# Access Compliance Report

## Public Rights-of-Way

### (Curb Ramps)

Intersection ID: 50594	Main Street: BEAR_GRASS_LN	Cross Street: GRAY_WILLOW_RD	Location: W
ADA ID: B2EC73B528CA	Ramp Type: Perp	Initial Pass/Fail: Fail	Overall Compliance: No
Severity Score: 21.25			
Codes/Mitigation Info/Possible Solution		Field Measurements/Component Compliance

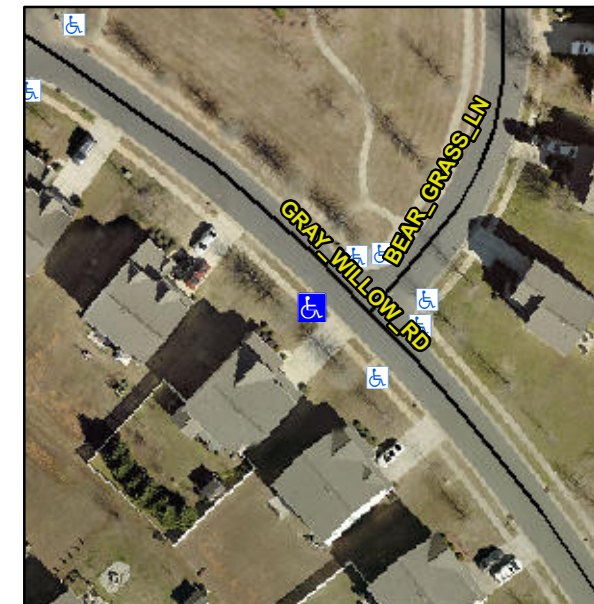
**Not Found, R304.5.1, R304.2.2**

Compliance	Description	Data	Compliance	Description	Data
N/A	Ramp Length (in)	48.5	No	Ramp Slope (%)	8.6
No	Ramp Width (in)	47.5	Yes	Ramp XSlope (%)	1.7
N/A	Flare Type LT	N/A	N/A	Flare Type RT	N/A
N/A	Flare Slope LT (%)	N/A	N/A	Flare Slope RT (%)	N/A
N/A	Flare Traversable LT?	N/A	N/A	Flare Traversable RT?	N/A
N/A	Landing Length (in)	N/A	N/A	DWS Provided?	N/A
N/A	Landing Width (in)	N/A	N/A	DWS Contrast?	N/A
N/A	Landing Slope (%)	N/A	N/A	DWS Length (in)	N/A
N/A	Landing X Slope (%)	N/A	N/A	DWS Full Width?	N/A
N/A	Landing Curb? (Y/N)	N/A	N/A	DWS Offset (in)	N/A
N/A	Shared Landing?	N/A			
N/A	Gutter Ponding?	N/A	N/A	Gutter Slope (%)	N/A
N/A	Gutter Lip Ht (in)	N/A	N/A	Gutter X Slope (%)	N/A
N/A	Painted X Walk1?	No	N/A	Painted X Walk2?	N/A
	X Walk 1 Direction	To NE		X Walk 2 Direction	N/A
N/A	X Walk 1 Width (in)	N/A	N/A	X Walk 2 Width (in)	N/A
	X Walk 1 Slope (%)	2.0		X Walk 2 Slope (%)	N/A
	X Walk 1 X Slope (%)	1.5		X Walk 2 X Slope (%)	N/A

**Remove & Replace Entire Ramp.**
